UNITED STATES
NUCLEAR REGULATORY COMMISSION
WASHINGTON, D. C. 20555

SAFETY EVALUATION BY THE OFFICE OF NUCLEAR REACTOR REGULATION
CONCERNING A POSTULATED BREAKOUT OF SPIRIT LAKE
AND ITS IMPACTS ON THE TROJAN PLANT
DOCKET NO. 50-344

Date: July 16, 1985

FIGURE 2
LOCATION OF SPIRIT LAKE OUTLET

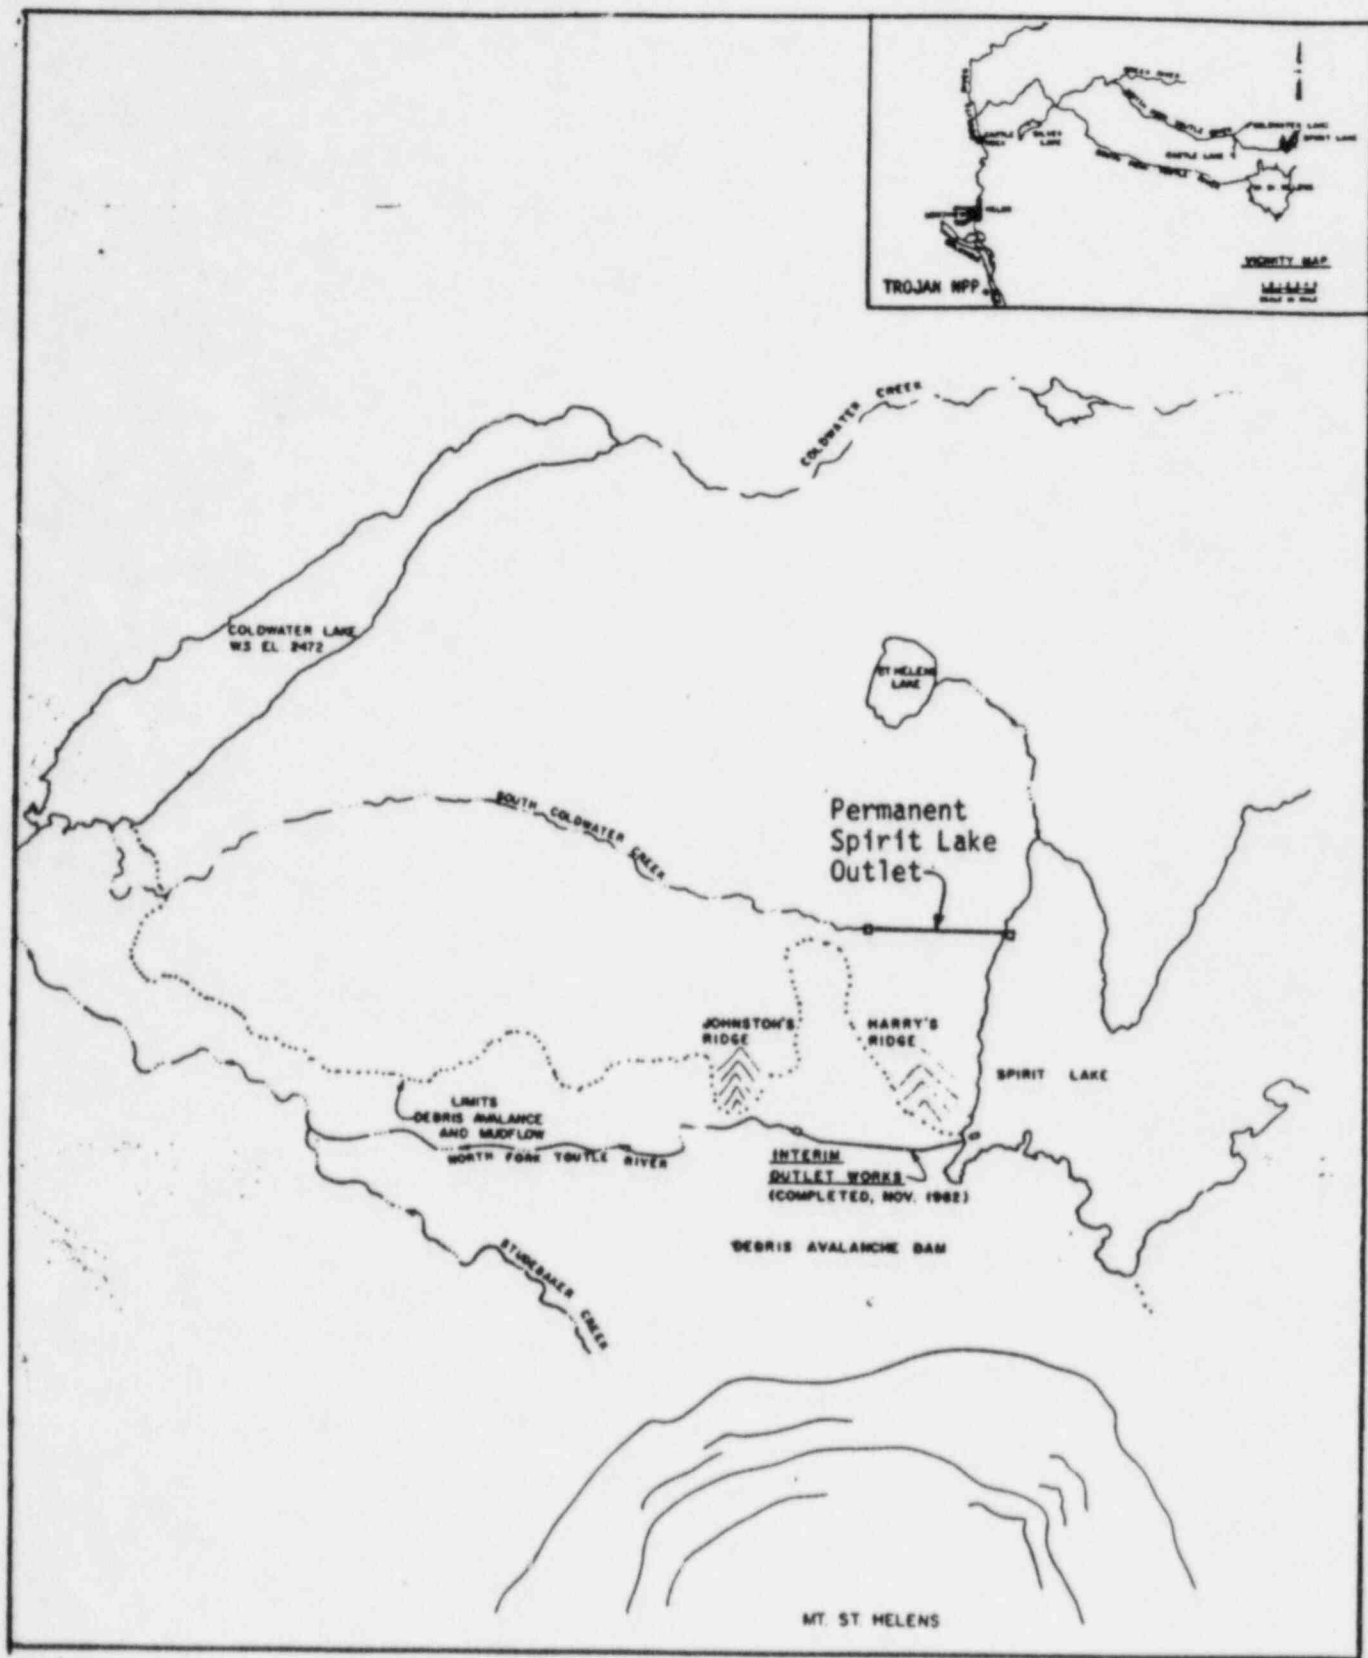
In the fall of 1981, a task force organized by the U.S. National Forest Service determined that the effective crest of the debris blocking the Spirit Lake outlet would deteriorate from elevation of 3490 ft to 3475 ft during the winter of 1982-83 because of subsidence and erosion. It was estimated that Spirit Lake would fill to elevation 3475 ft (314,000 acre-feet) sometime in March 1983 assuming that no action was taken to reduce the level and volume of the lake and that the annual inflow was average. Were this to happen, there would be a very high potential for failure of the blockage and catastrophic flooding downstream. To reduce the potential for failure, the Corps of Engineers, as an interim measure, constructed a pumping facility at Spirit Lake and pumping began on November 5, 1982 (see Figure 2). The goal of the pumping operation was to

The tunnel between Spirit Lake and South Coldwater Creek (See Figure 2) provides a permanent outlet for Spirit Lake. This tunnel will maintain the level of Spirit Lake at an elevation that will reduce the threat of a breakout and the potential for high water in the Columbia River at the Trojan Plant.
